MCPB ITEM NO.  
12-07-06

**MEMORANDUM**

**PROJECT:** Rockville Pike (MD355)/Montrose Parkway/Randolph Road Interchange From  
Old Georgetown Road to Maple Avenue/Chapman Avenue  
Contract No. MO 8305171

**REVIEW TYPE:** Mandatory Referral No. 06812-SHA-1

Attachment 5

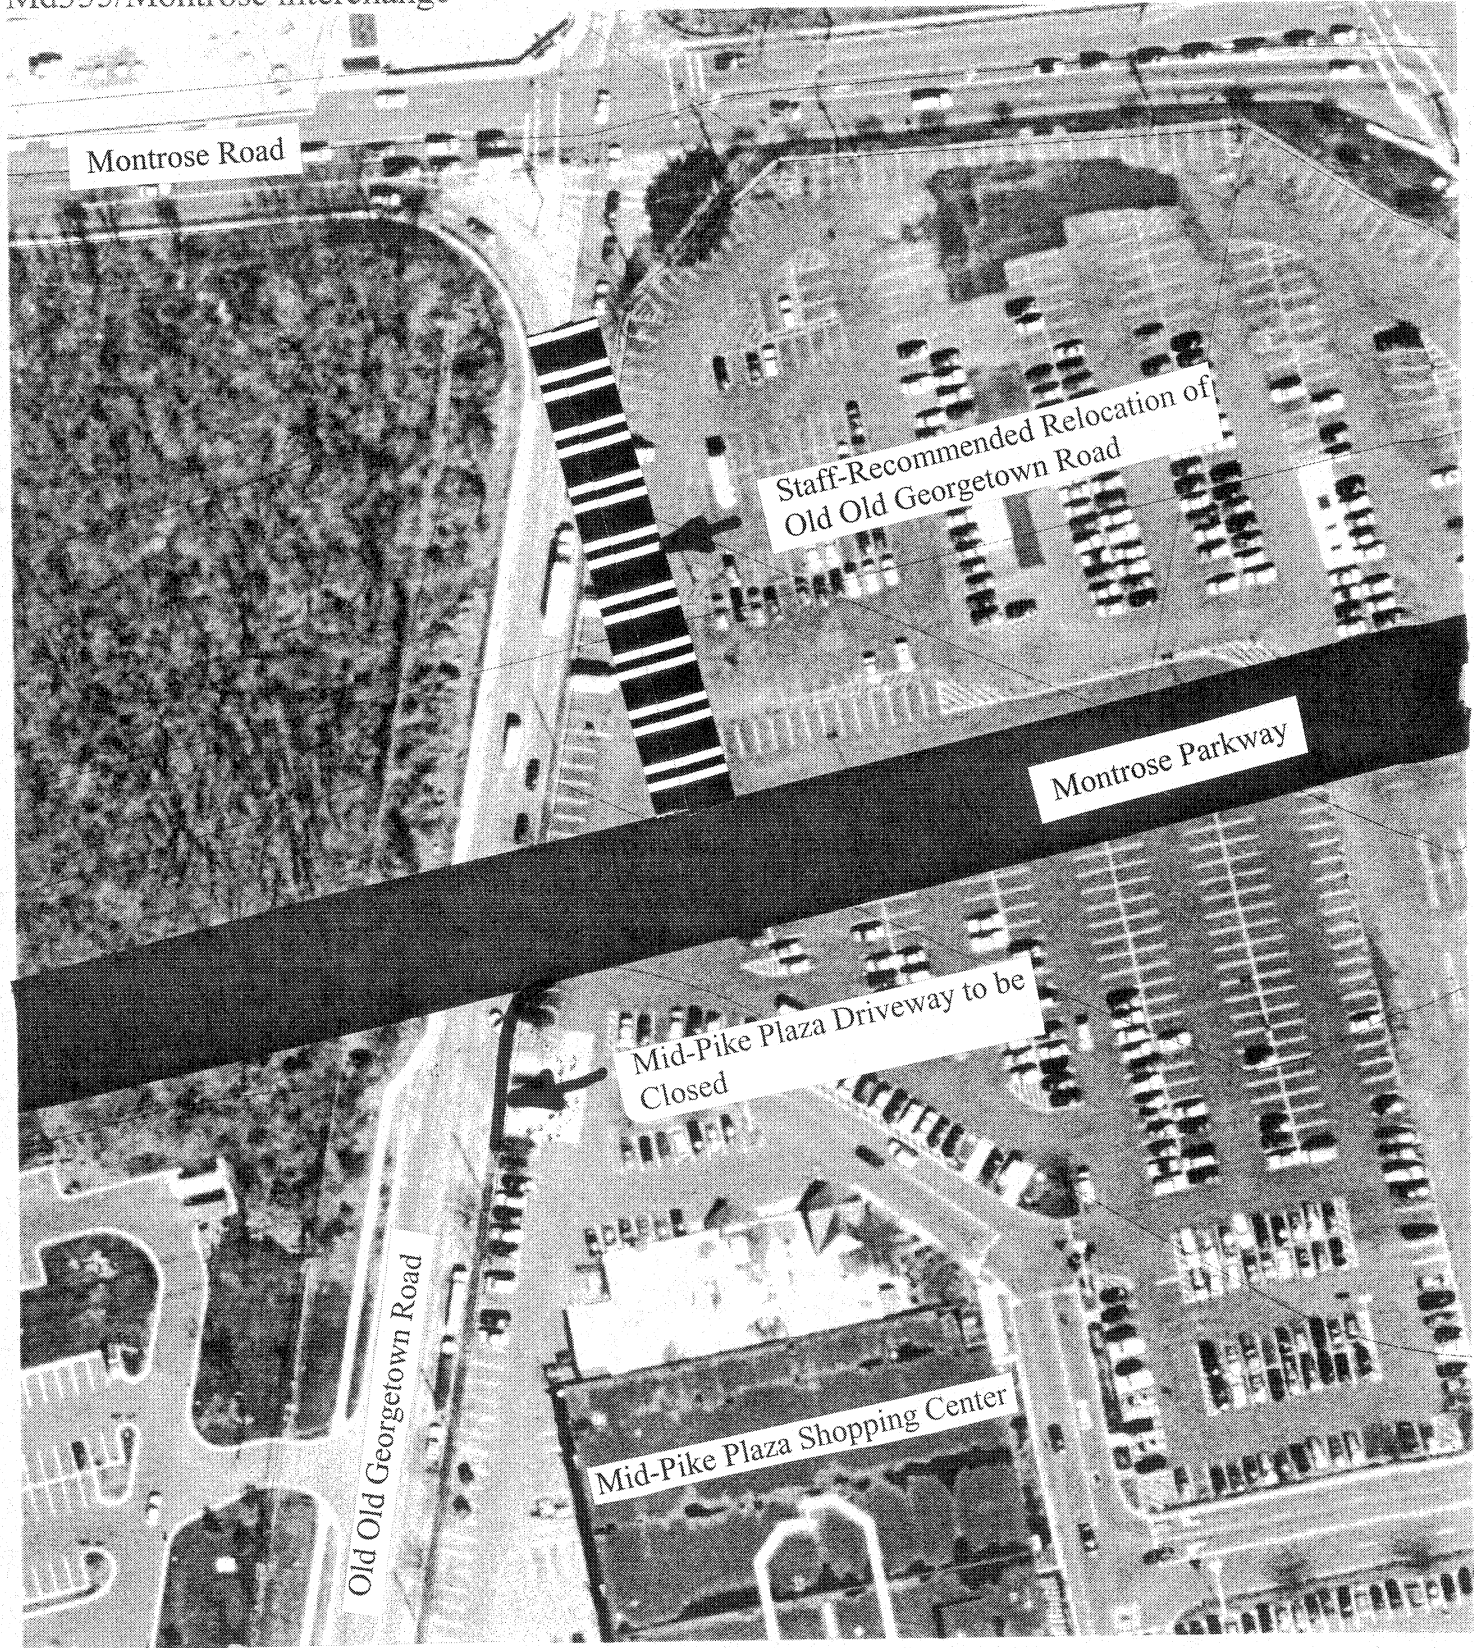
Staff believes that SHA should consider relocating the segment of Old Old Georgetown Road between Montrose Road and the Parkway to be perpendicular to the Parkway (see Attachment 5). As noted above, the utility pole relocations have already been done for this project and therefore a couple of poles would likely have to be moved again. However, staff believes that the need for efficient and safe operation of the roadways in this area demands that such realignment be given serious consideration.

A realignment of this segment of Old Old Georgetown Road would create an offset with the existing southern segment of Old Old Georgetown Road. The southern segment has a much lower traffic volume and staff believes that a better overall traffic operation for the north and east legs of the intersection would be sufficient to warrant the change.

As a reply to SHA's response, staff believes that a final decision on this issue must happen before this project is built. The site of the proposed intersection is partly a parking lot and partly a little-used road. While there would be an additional expense to relocate a couple of utility poles to effect the recommended realignment of Old Old Georgetown Road as part of this project, the cost would be dwarfed by having to reconstruct the proposed intersection in the future with almost 100,000 cars passing through it on an average day on Montrose Parkway.

*Relocating the segment of Old Old Georgetown Road between Montrose Road and Montrose Parkway to be perpendicular to the Parkway would offset this relocated leg by 100' +/- from the leg of Old Old Georgetown Road south of Montrose Parkway. The Old Old Georgetown Road southern leg movements through this intersection would be undesirable since a right in / right out condition would be warranted impacting anyone wanting to go west on Montrose Parkway and Montrose Road. This right in/right out would be within 100 feet of the main intersection. In*

*addition to the intersection issues, recently relocated utilities would be impacted, the anticipated park and ride lot would need to be reduced, and SWM Pond 2 would need to be re-sized.*

*It should be noted that AASHTO states the following in Chapter 9 Intersections (2001 Edition pg.585): "Although a right-angle crossing is normally desired, some deviation from a 90-degree angle is permissible. Reconstructing an intersection to provide an angle of at least 60 degrees provides most of the benefits of a 90-degree intersection angle while reducing the right of way takings and construction costs often associated with providing a right-angle intersection."*

*If and when Mid-Pike Plaza is redeveloped, the issues noted above would be re-considered and changes incorporated as deemed appropriate at that time.*
